SERVICE BULLETIN

#0017

SUBJECT: Potential risk of shearing of control stop plate rivets

MODELS AFFECTED: Sling 4 and Sling 4 TSi aircraft

Figure 1 - Elevator control torque tube for Sling 4 and Sling 4 TSi aircraft

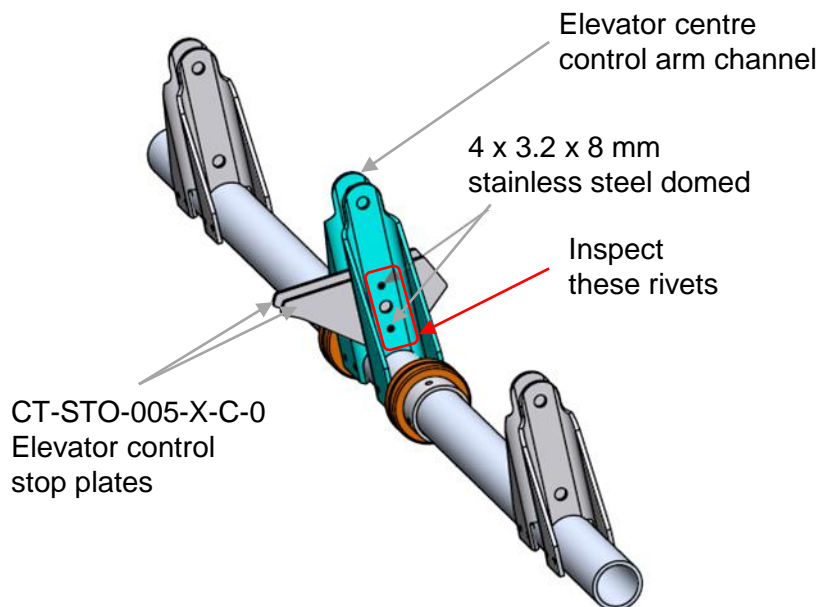
1. The rivets on the torque tube that need to be inspected are shown in Figure 1. The control stop plates (CT-STO-005-X-C-0) and elevator centre control arm channels are also shown in Figure 1.
2. Remove a front seat from the fuselage then use the 2 mm / 2.5 mm Allen key to remove the floor skin (refer to CF-SKN-016-R-C-0) shown in Figure 2.
3. The inspection region when the floor skin is removed is shown in Figure 3. Use the light source to determine if control stop rivets are aluminium or stainless steel. Use Figure 4 as a guide for making the distinction.
4. Alternatively (or in addition to using the light source) use a magnet to identify rivets. The mandrel of the aluminium rivet used is magnetic, so a magnet will attract to the aluminium rivet (see Figure 4).

13. On the control stop plate, remove the aluminium rivet and install the 3.2 x 8 mm stainless steel rivet. Apply this remedy one rivet at a time to prevent the control stop plate from detaching from the control tube.

Figure 3 - Region of inspection area and seat rail

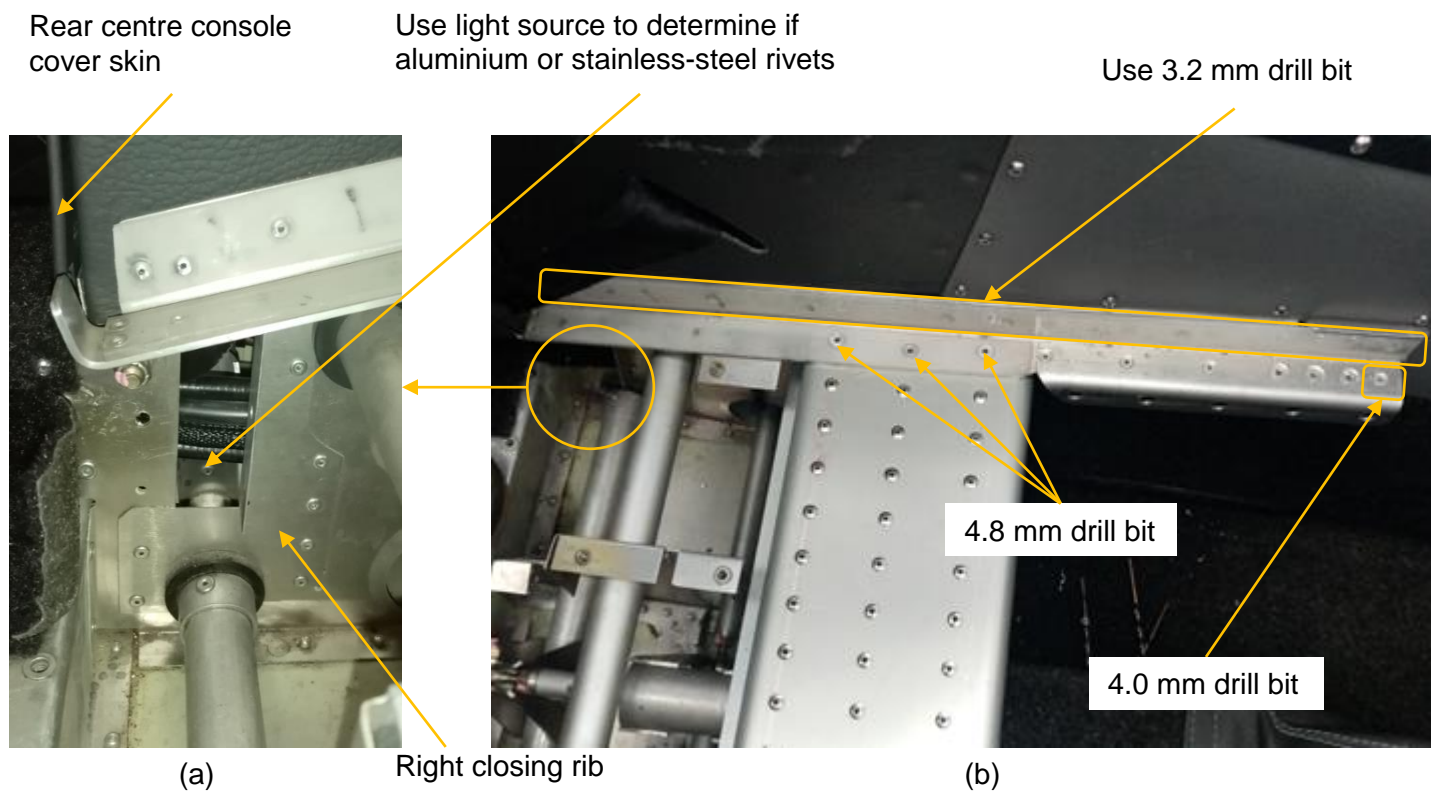
7. Drill the heads off the countersunk rivets shown in Figure 3(b) with the angle drill (using 3.2 and 4.8 mm drill bits) to remove seat rails.
8. Remove and retain all M3 / M4 screws on the aft section of the centre console to separate it from the forward section as shown in Figure 5(a).

11. Cut the cable ties that guide the centre console wiring and pitot static tubes (using the side cutter) to reduce their tautness, then use the angle drill and 3.2 mm drill bit to drill heads off the rivets on the closing rib as shown in Figure 5(b). The closing rib on the centre console RH side is shown in Figure 3(a).

17. The AN4 lock-nuts (hardware designation AN365-428A) must be tightened such that the seat belt brackets can still swivel.
18. Install the controls closing ribs (CF-RIB-009-R/L-C-0 shown in Figure 3(a)) using the 3.2 mm clecos to align the holes. Assemble with (20) 3.2 x 8 mm aluminium domed rivets.

20. Return the seat rails, including the plastic plates, using clecos to align the holes before riveting. Use the hand riveter, two 4.0 x 10 mm and six 4.8 x 15 mm countersunk aluminium rivets to assemble the seat rails. In addition, install the (18) 3.2 x 10 countersunk aluminium rivets on the upper rails (see Figure 3(b)).
21. Return the rear centre console cover skin and the floor skin shown in Figure 3(a).
22. Any dome head cap screws experiencing resistance during assembly should be cleaned with an M3 / M4 thread tap (tap size depending on year model).

Figure 5 – Disassembly of centre console and removal of CF-RIB-009-R/L-C-0

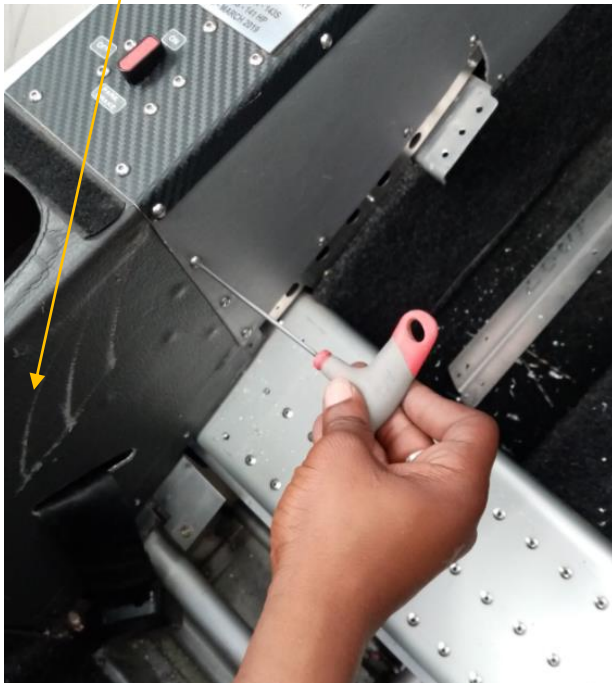
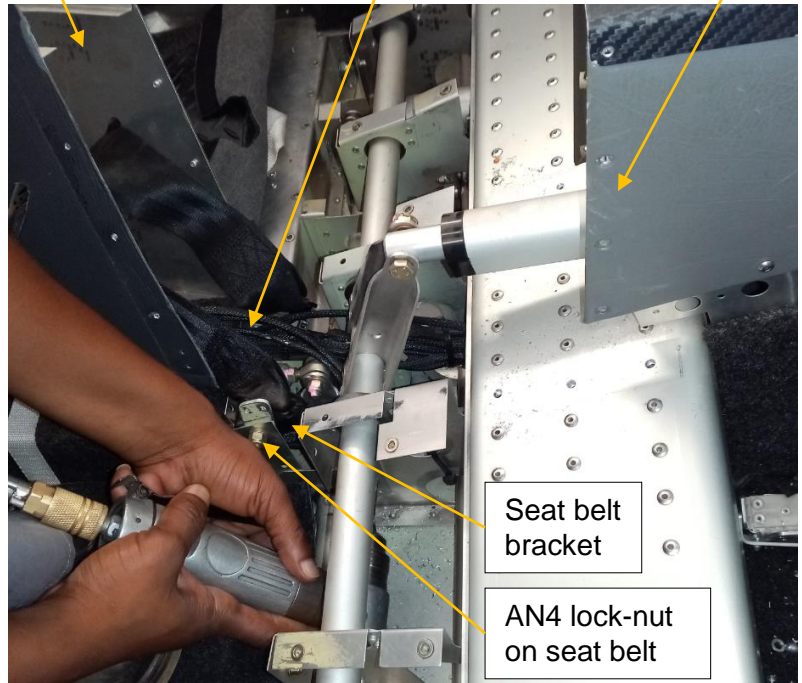
9. The aft section of the centre console must be carefully pulled away so as not to damage wiring and pitot static lines running through the console as shown in Figure 5(b). If resistance is felt separating the aft and forward centre console sections, the headset jacks should to be removed with the 14 mm spanner and socket. Be sure to label these cables left and right so that they are refitted in their original positions (see Figure 6).

12. Use the 7/16" spanners to loosen the AN4 lock-nuts (hardware designation AN365-428A) on seat belt shown in Figure 5(b) so that the seat belt bracket can swivel. This will ensure there is sufficient room for the hand riveter to be pressed firmly against elevators' centre control arm channel when installing the 3.2 x 8 mm stainless steel rivets (See Figure 7).

19. Return the aft section of the centre console using the 2 mm / 2.5 mm Allen key and install the M3 / M4 screws (see Figure 5(a) which shows disassembly).
